Special Meeting of Council Agenda

Item	Page	Rec. Page	Report Presenter
4.1 Amendment C231 - Queens Parade	4	25	Fiona Van der Hoeven, Assistant Manager City Strategy

Reference: D20/18744
Authoriser: Director Planning and Place Making

Map 3: Location of 390A Queens Parade

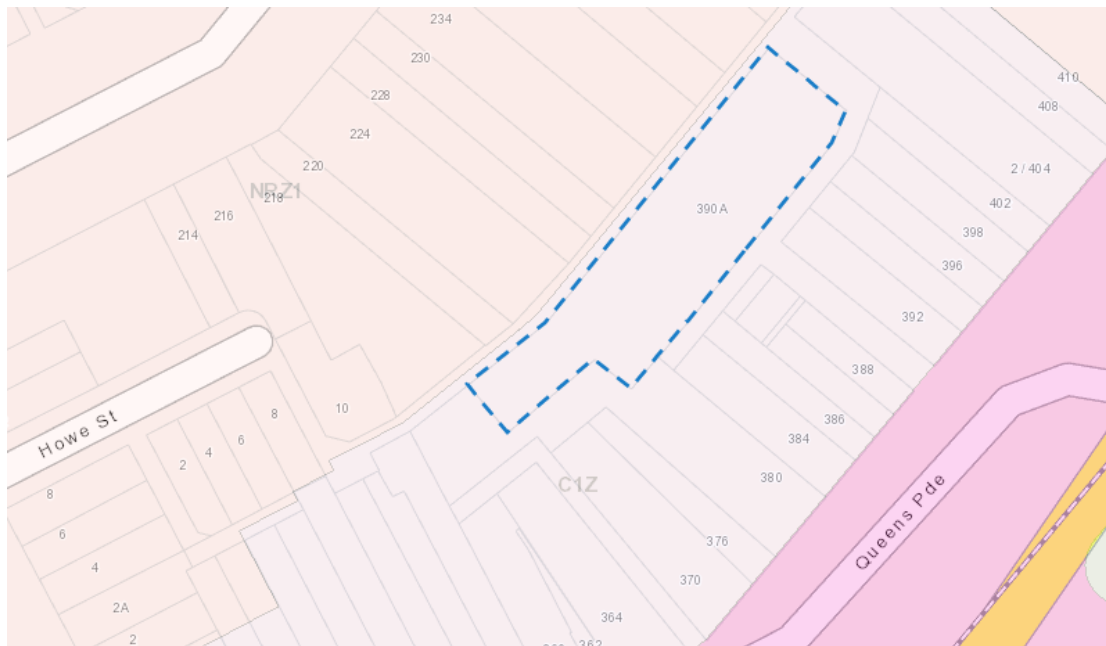
111. There is currently a planning permit application being considered for the land. The planning permit seeks to demolish all existing buildings on the site and construct 15 four storey townhouses. The permit applicant appealed Council's 'failure to determine the application' within the statutory timeframe to the Victorian Civil and Administrative Appeals Tribunal (VCAT).

112. Officers from Council's statutory planning branch advised the VCAT that Council would have issued a refusal based on issues such as loss of heritage fabric, building bulk, impacts on the ability of neighbouring commercial properties to develop, internal amenity and street address.

127. Accordingly, further work is required but the matter cannot be progressed as part of this Amendment. It cannot be progressed because it was never part of this Amendment, it was not exhibited and the owner has not been given a reasonable opportunity to test the propositions in the context of a panel hearing noting that the recommendation came out of the C231 Panel. Therefore, officers are of the view that the issue would need to be pursued as part of a future planning scheme amendment. This would enable the proposal to be fully and properly considered through a public process.

Figure 1: Aerial dating to c.1925-40. Source: GJM Heritage Analysis, Appendix G, p.23. The red arrows show the location of the present buildings including 'a', 'b' and 'e', which were extant at the time. The yellow arrow indicates the vacant land now occupied by an extension to building 'b'.

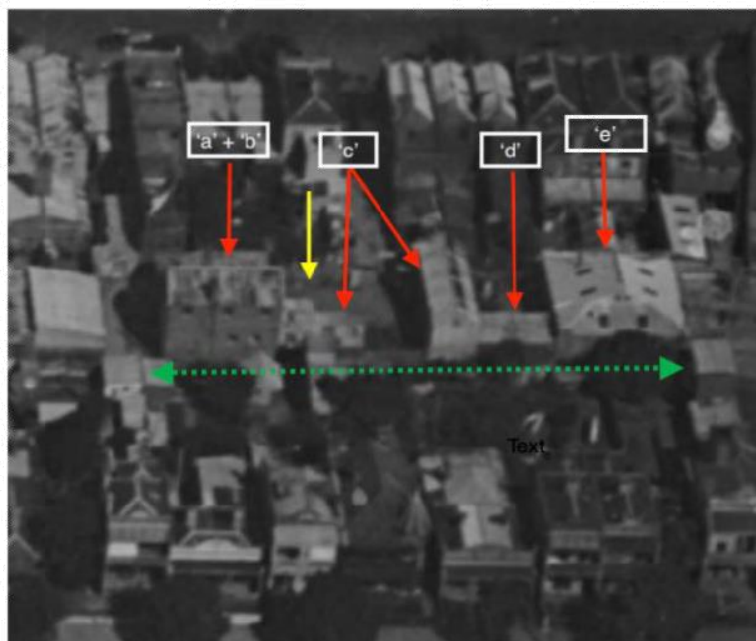
Figure 1 is a c.1925-1940 aerial photo reproduced in both the GJM and Lovell Chen reports that provides a useful snapshot of the subject site during the interwar period.

Building	Assessment	Recommendation
'd'	<p>The north wall of this building may include part of the original wall of the early stables building shown in Figure 1. However, this is all that remains and the building has been significantly altered.</p> <p>Comparable to 304 Queens Parade as a simple utilitarian structure that can no longer be understood as dating from a particular period and is not considered to have heritage value.</p>	Does not warrant a Contributory grading. Retain Not contributory grading as proposed by Amendment C231.
<div>  <p><i>The remnant north wall of the building. Note how upper section of wall is partially out of alignment (i.e., leaning toward the lane) and use of different bricks in the upper section</i></p> </div> <div>  <p><i>Detail of north wall showing remnants of corbelling</i></p> </div>		
'e'	<p>While this building dates to c.1930, it is a plain brick building, which has no distinguishing features apart from the half-gabled roof. Part of the south elevation is obscured and the visible west elevation has been significantly altered.</p> <p>It is comparable to 304 Queens Parade as a simple utilitarian structure that can no longer be understood as dating from a particular period and is not considered to have heritage value.</p>	Does not warrant a Contributory grading. Retain Not contributory grading as proposed by Amendment C231.

Figure 2: Plan of area to be rezoned and application of EAO in Precinct 3

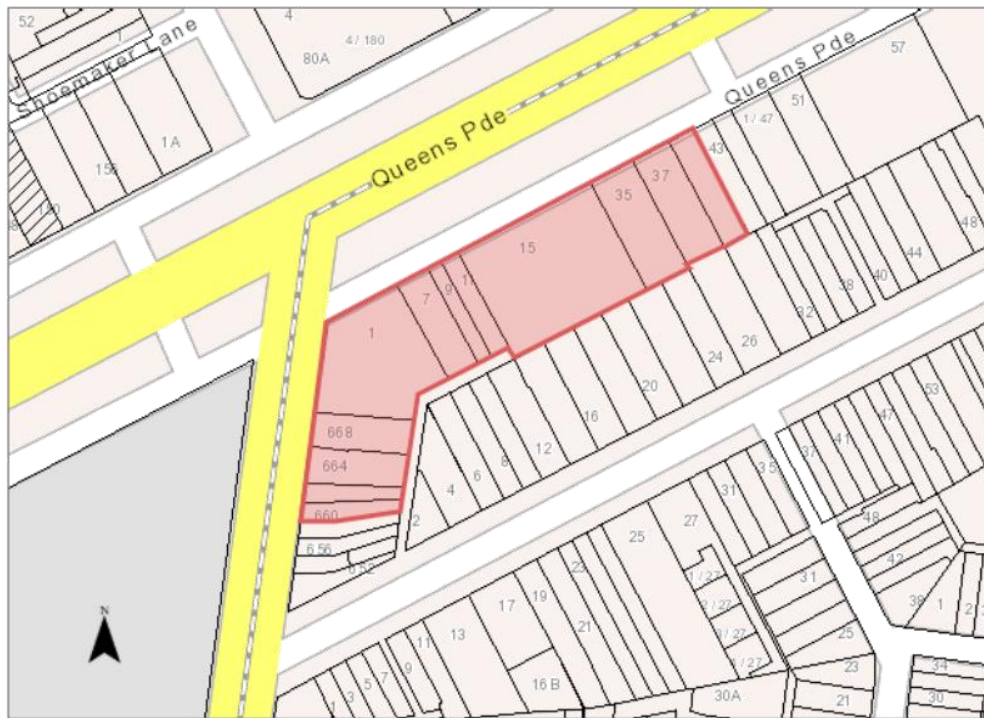
The Amendment proposes to rezone an area of land located in Precinct 3 at 660 – 668 Smith Street and 1 – 41 Queens Parade from the C2Z to the C1Z and apply the EAO over that parcel of land (Figure 2).

104. In response to this and other submissions, Council at its ordinary meeting of 28 May 2019 supported the rezoning of the site and recommended this change to the Panel.

Figure 5: Map of Precinct 3

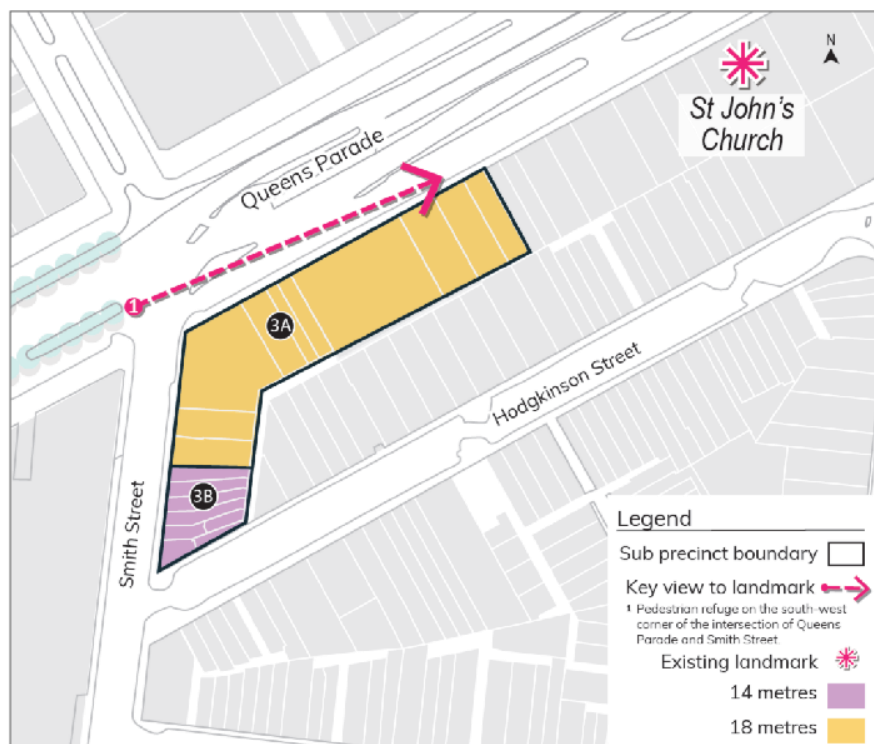
Mr Parsons questioned the value of the mandatory requirement to require clear sky to be retained around the spire and belfry of St Johns Church when viewed from the key viewpoint identified in Figure 5. He opined that while the viewpoint in the preferred DDO16 allowed a view of the spire, it was not helpful in assessing the impact of different heights. He observed this view was not noticeably impacted by development at heights greater than the proposed mandatory maximum height of 18 metres.

The Panel considers this confusion was partly due to modelling of the view that did not accurately reflect the conditions (e.g. Figure 7.9 in Mr Parsons evidence statement). The modelling did not include any trees, street infrastructure or street furniture that in the actual view, impact or partly obscure the view. To appreciate all components of that view, a viewer standing in the nominated location would have to make several observations from several slightly different locations.

Figure 6: Map of Precinct 4

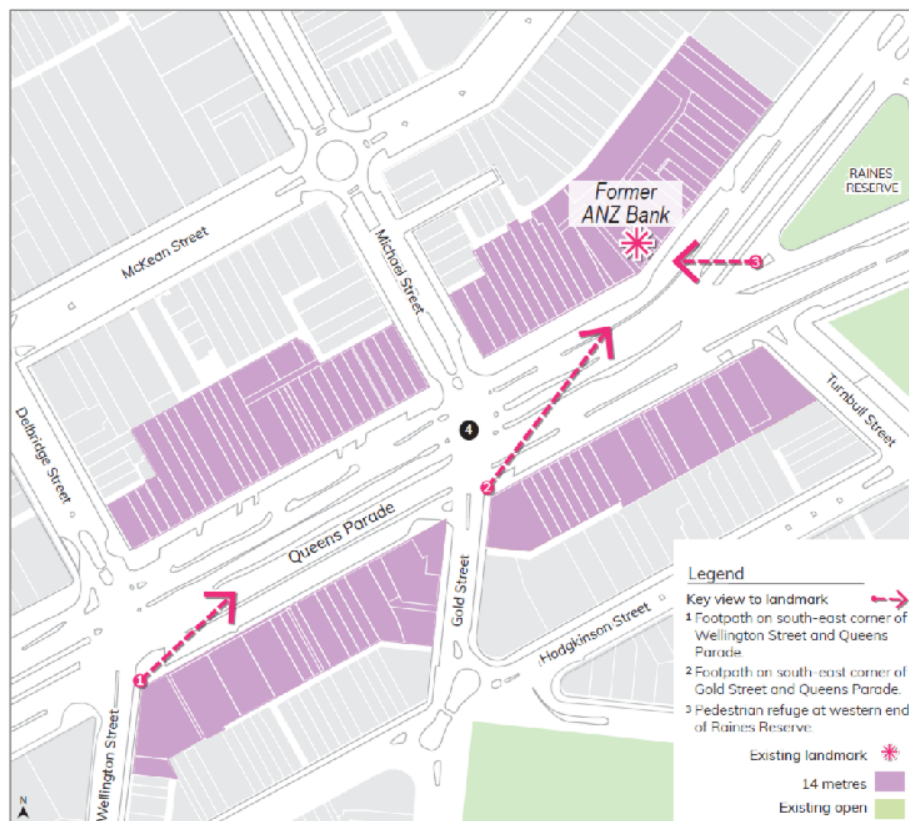
68. The Panel recommended a height of 10.5 metres (three storeys) in the majority of Precinct 4 with the fourth quadrant bounded by Queens Parade, Gold Street and Turnbull Street to remain at 14 metres (four storeys) (see Map 1). The Panel explained that it considered:
- the contribution made to the character of the area by the consistent and fine grained detail and heritage features in this area warrant a mandatory height limit of 10.5 metres (three storeys); and
 - the quadrant between Gold and Turnbull Streets has larger lots, two street corners and less consistent heritage qualities; blank side walls may have less impact and there is capacity for more development.
